1 APPLICATION SUMMARY

**REPORT ON DEVELOPMENT PERMIT FOR MATERIAL CHANGE OF USE AND
RECONFIGURING A LOT (CODE ASSESSMENT) FOR 1 INTO 25 LOT SUBDIVISION, ACCESS
EASEMENT, NEW ROADS AND DUAL OCCUPANCY (6) AT 54 GEORGE ALEXANDER WAY,
COOMERA**

COM/2023/16

Figure 3 - Proposed Stage 3 of ROL (Source: Saunders Havill Group)

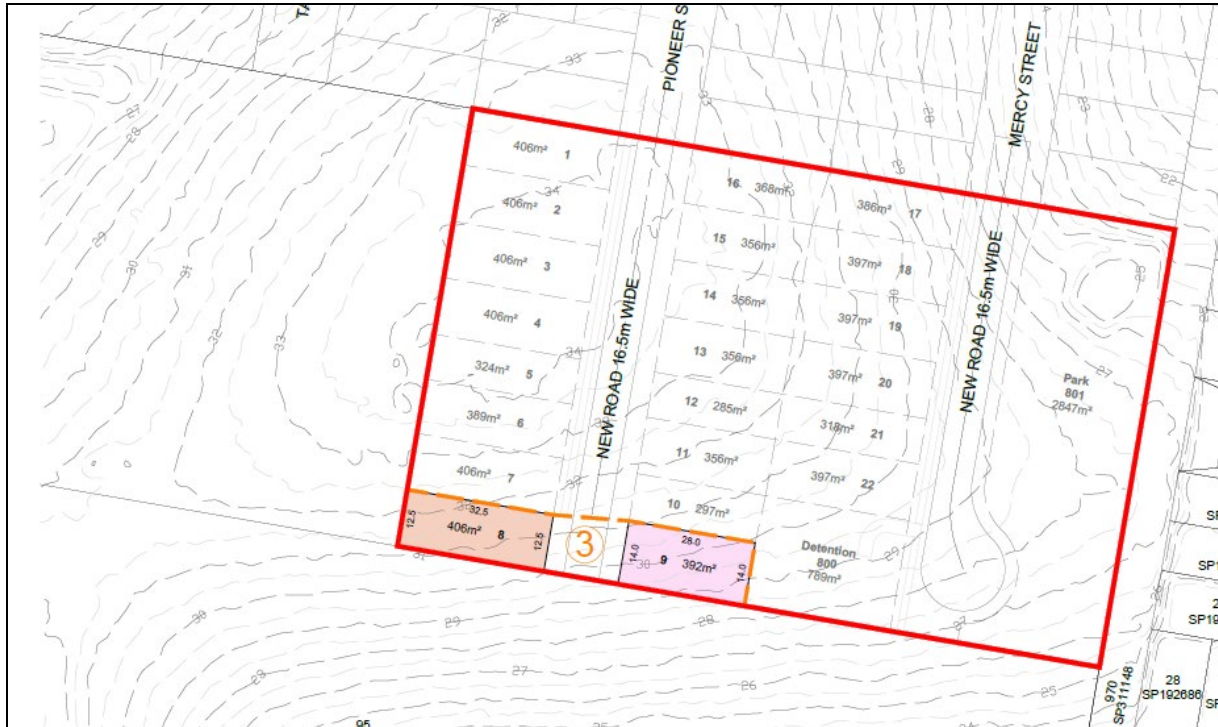
Officers have recommended a condition which does not allow Stage 3 to be plan sealed until a through road connection to the south is delivered and the bushfire risk has been appropriately mitigated for Lot 8 and 9
Yield	25 total including 22 residential allotments, 1 Open space (recreational), 1 Open space (drainage) and 1 balance lot
Residential lot sizes	297m ² – 406m ²
Balance lot (management lot)	Proposed Lot 1 – 1.5ha (Stage 1)
Open space lots	• Recreation (park) – 2847m² • Drainage – 789m²
Road access	From Pioneer Street and Mercy Street to the north. To ensure Mercy Street is designed to achieve the full 16.5 metre wide road profile as required by the Land development guidelines, Officers have included an amended plans condition for the road alignment to be altered as part of the ROL. This will reduce the width of Lots 17-22 by 1.5 metres to accommodate the full verge width. Officers do not support a reduction in the width of the park lot.

Plan sealing for Stage 3 cannot occur until such time as the bushfire risk from the south is appropriately mitigated for proposed lots 8 and 9.

The submitted plan demonstrates compliance with Performance outcome PO1. To appropriately mitigate the bushfire risk from the south, Officers have included a specific timing condition that does not allow for plan sealing of Lots 8 and 9 until such time as the bushfire risk from the south has been appropriately mitigated.

Figure 6 - Type 2 Level 1 floor plan (Source: Ultra Linea Architecture)

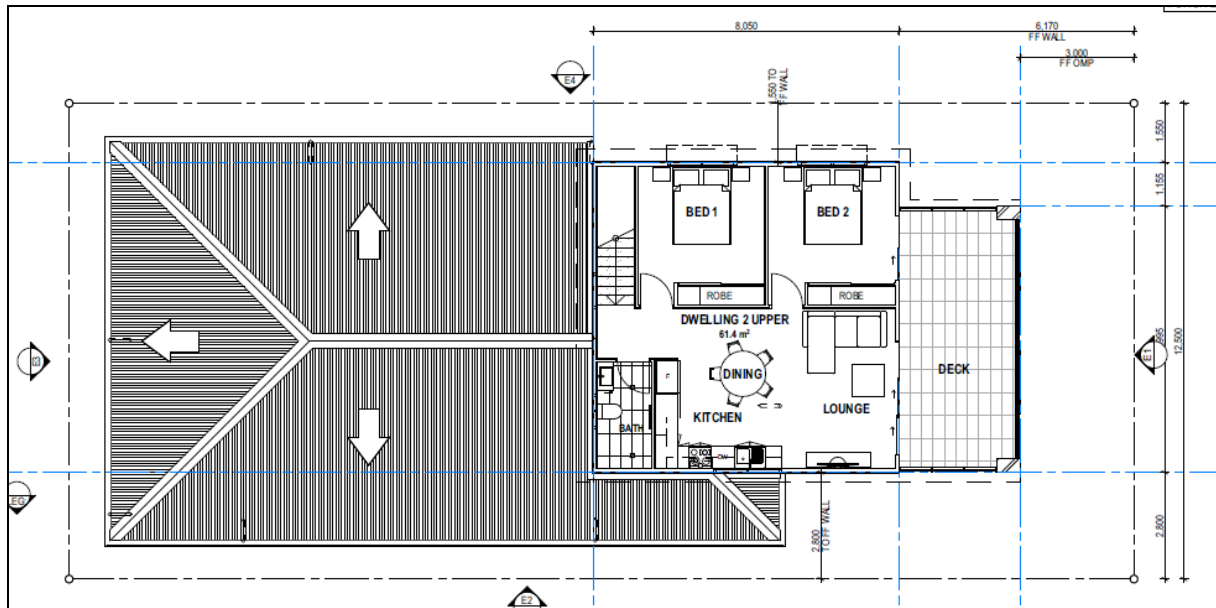
For the upper dwelling, the private open space ranges from 12.4m²-13.2m² and does not provide minimum dimensions of 5m x 5m. The following provides assessment to demonstrate compliance with Performance outcome PO5.

Proposed Dwelling 2 includes a balcony for each dwelling type that is adjacent to the lounge room and bedroom 2 and is therefore suitably located. The balcony includes a length 7 metres and a width of 3.2 metres. This is considered sufficient to facilitate the recreational needs of the residents. It is also noted that residents have access to the ground floor (adjacent to the entry of the dwelling) which could provide access for private open space needs and also the approved parks within the subdivision.

Figure 15 - Roadworks extent plan (Source: Burchills Engineering Solutions)

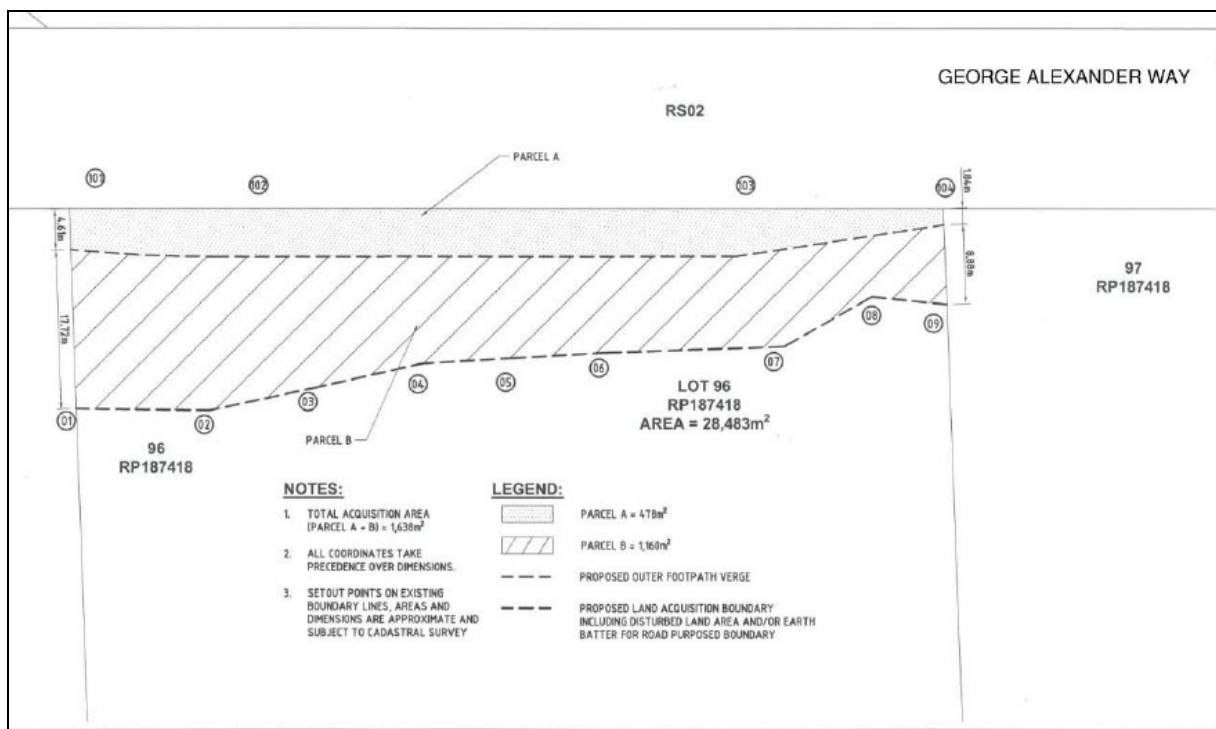
The proposed development is located adjacent to RD_0019 (Road H) as identified on LGIP for trunk transport infrastructure. To achieve the ultimate planned road upgrades for George Alexander Way, the development is required to dedicate 1,683m² of land for future road widening purposes.

Figure 19 - Civil drawings (Source: Burchills Engineering Group)

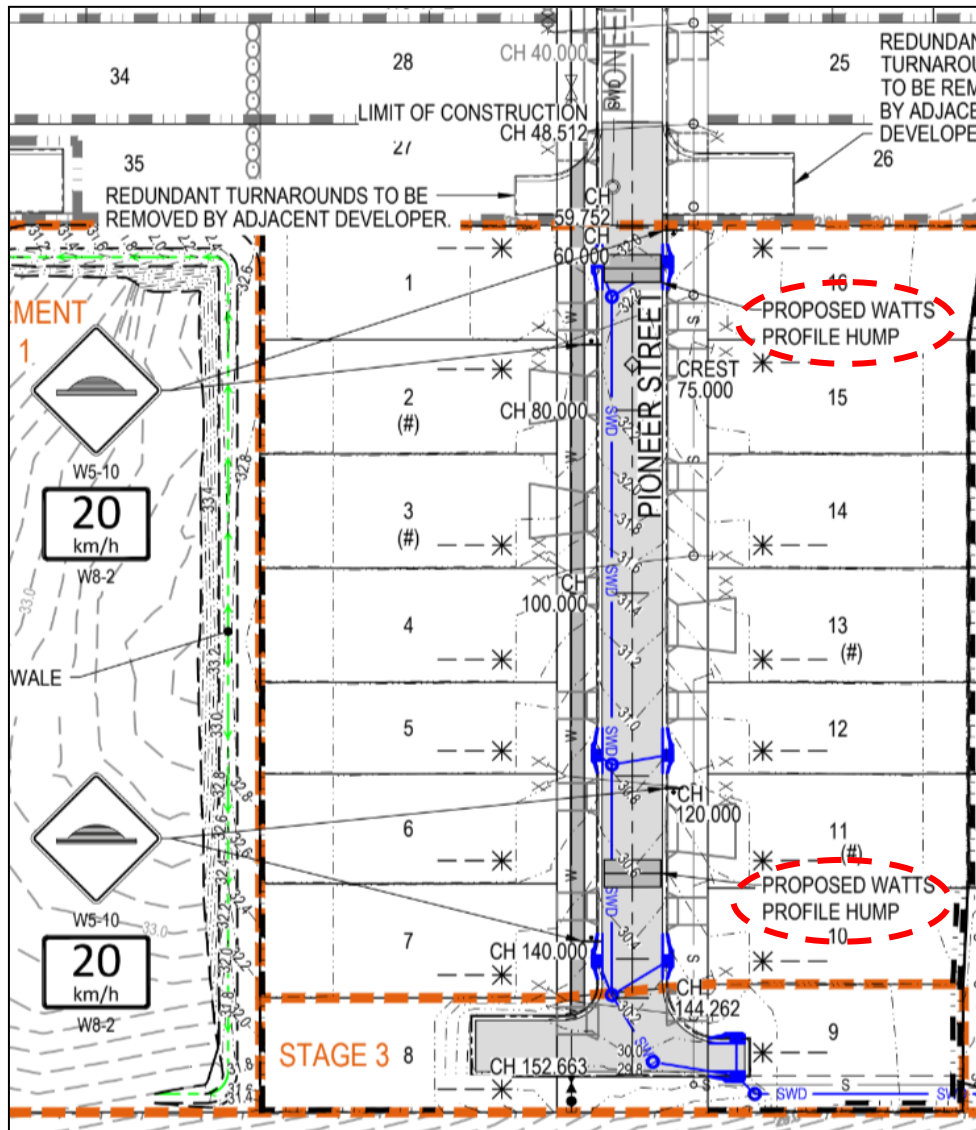
Given the topography of the site, to achieve safe sight distances, two speed humps are required in Pioneer Street (as demonstrated in Figure 18 below).

Officers have included a specific condition to ensure the VXO's for proposed lots 1, 2, 3, 4, 13, 14, 15 and 16 are constructed prior to plan sealing. This ensures safe sight distances are achieved in accordance with must meet the safe sight distance requirements of 3.2.4 of AS/NZS 2890.1:2004.
